Report of the Promontory Point Mediator

This report was prepared at the request of Alderman Leslie Hairston and commissioned by the South East Chicago Commission. Its purpose is to provide an independent review of the feasibility of a "preservation" design for the restoration of Promontory Point.

The review was conducted by Wayne Brunzell. Mr. Brunzell is a civil engineer with a strong background in structural engineering. Since October of 2003, he has served as technical advisor to the Promontory Point mediation process. He was selected for this role with the agreement of the parties represented in the Promontory Point Working Group (the Chicago Department of Environment, the Chicago Park District, the United States Army Corps of Engineers, and the Promontory Point Community Task Force).

Figure 1

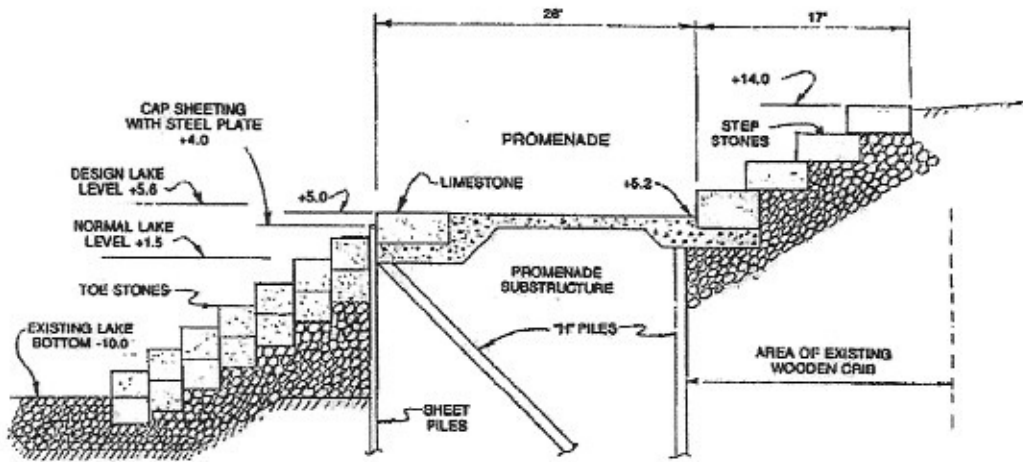
The vehicle for this inquiry is review of a single design concept. The design we have chosen for this purpose is shown in Figure 1. The essential features of this design are four limestone steps and a promenade that incorporates limestone on the outer (lakeside) edge.

They differ in one minor respect. The Figure 1 design replaces the shear key in the City design with additional batter pile. [See Figure 2.] This modification is a different way of performing the same function at the same level of structural performance.

The Figure 1 design requires only limited milling of stone. The promenade stones will require milling, as will the bottom step stone. This represents roughly 40% of the stone to be used in the project.

As noted, the design under review is a four step structure constructed with a single layer of stone. The shoreline of Promontory Point is 3215 feet. We have assumed 2.87 tons of stone per foot. This yields a total of 9,240 tons:

The Figure 1 design incorporates limestone blocks into the outer (lakeside) edge of the promenade. [See Figure 1.] We have assumed 0.46 cubic yards of stone per foot. This yields a total of 2, 888 tons:

The single stone block located on the edge of the promenade does not meet normal stone design standards for a structure subjected to direct wave attack. This stone is located in an area that will be subjected to frequent and intense breaking wave attack. Normal design standards call for stone structures to be incorporated into an interlocked revetment. The placement of a single stone on a concrete slab held in place with a simple steel angle at its toe is not a standard approach. There is not design guidance available that we are aware of for this approach; however, it is clear that the potential for stone movement and dislocation could be significant. The variable nature of wave attack will result in the rocking and displacement of these stones due to ice jacking and wave attack. We expect that the steel angle constructed on top of the sheet pile will periodically be bent and otherwise damaged by both moving toe stones and stone blocks. Although the toe berms would be initially constructed to the same elevation as the promenade stone block, the toe berm can be expected to move and settle differentially resulting in some of the promenade stone blocks being exposed to direct wave attack with no fronting stone.

These are legitimate concerns. For the purpose of evaluating the adequacy of the limestone step stones in the Figure 1 design, directly relevant evidence is available to us: the condition of the existing structure. Such evidence is not available with respect to the incorporation of limestone blocks into the concrete promenade.

The question of whether this design feature is advisable is best answered in the course of the design refinement process. We strongly urge that the concerns raised by STS be heavily weighed in that process.

Figure 2

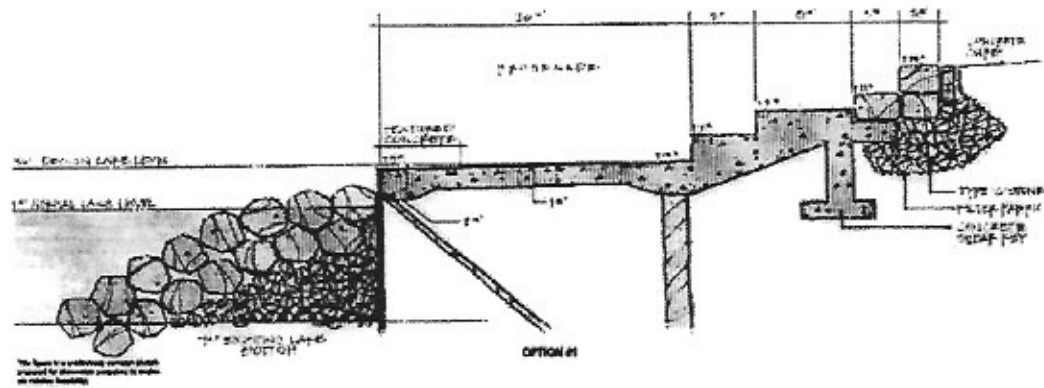
Option 1 is the City's proposed design incorporating limestone blocks as the two upper steps of the revetment. [See Figure 2.] STS writes: "this option replaces the upper portions of the concrete steps with two stone steps to be constructed of reused limestone blocks. . . . There appears to be sufficient available stone on site for reuse so that new stone blocks would not have to be imported."

Figure 3

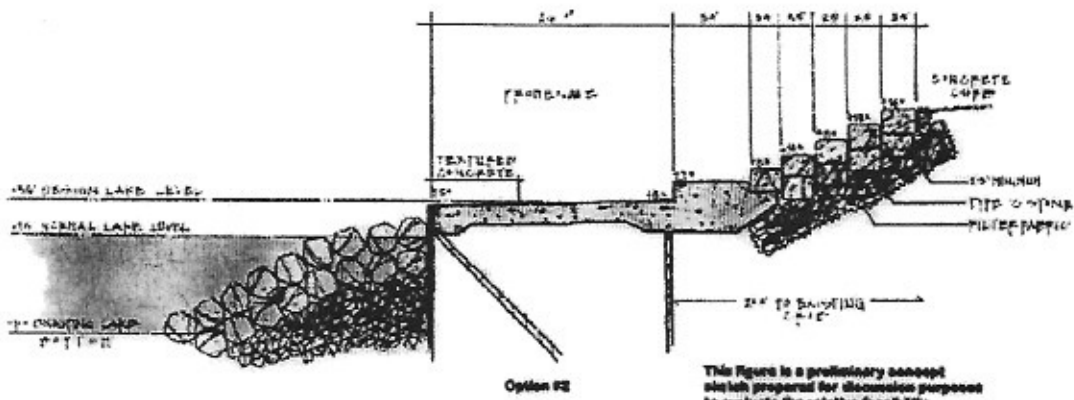
Option 2 includes a first step of concrete and five limestone steps. [See Figure 3.] "This option is similar to Option 1 except that the majority of the steps would be constructed of stone. The one concrete step to be constructed at the bottom will serve as a buttress to the step stones constructed above."

Taken on its own terms, the STS analysis yields an inexplicable result. Option 1 uses three stones; Option 2 uses nine stones; and Option 3 uses ten stones. Assuming the stones used in each option are the same dimensions, what explains the pronounced difference in estimated costs between Option 2 and Option 3, the all-stone design?

Figure 4

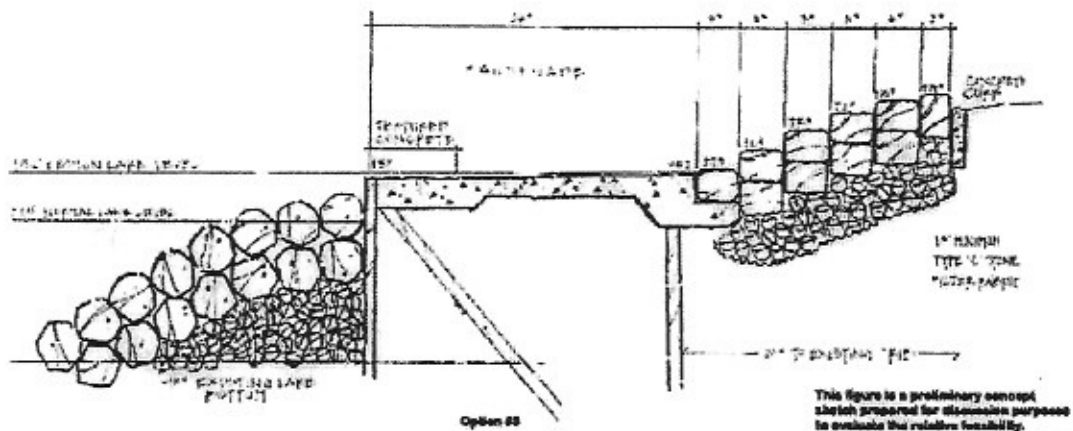
Option 3 most closely resembles the step stone configuration in the design under review in that all the revetment steps are of limestone. [See Figure 4.] It differs from the Figure 1 design in that it has five rather than four steps and makes use of ten rather than four stones.

Does Option 3 assume that all stone for the revetment structure will be purchased? Does it not include the reusable stone on site reflected in Options 1 and 2? In light of that possibility, we decided to assume for analytic purposes that the entire step stone structure will be built of new stone and that stone on site will be used exclusively in the toe berm structure.

Figure 5

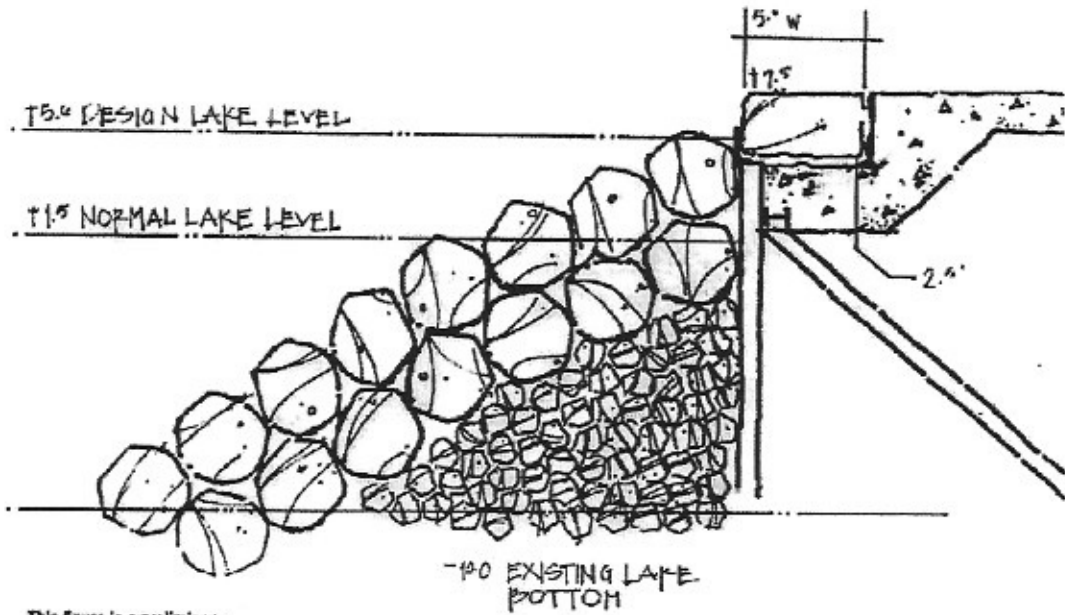
The design under review can be loosely characterized as a combination of Option 3 and Option 4—see Figures 4 and 5—in the STS report of January 27 with the following differences:

- It has four rather than five limestone steps.
- There is no limestone incorporated into the inner edge of the promenade.
- A single rather than a double layer of limestone blocks is used in the step stone structure.
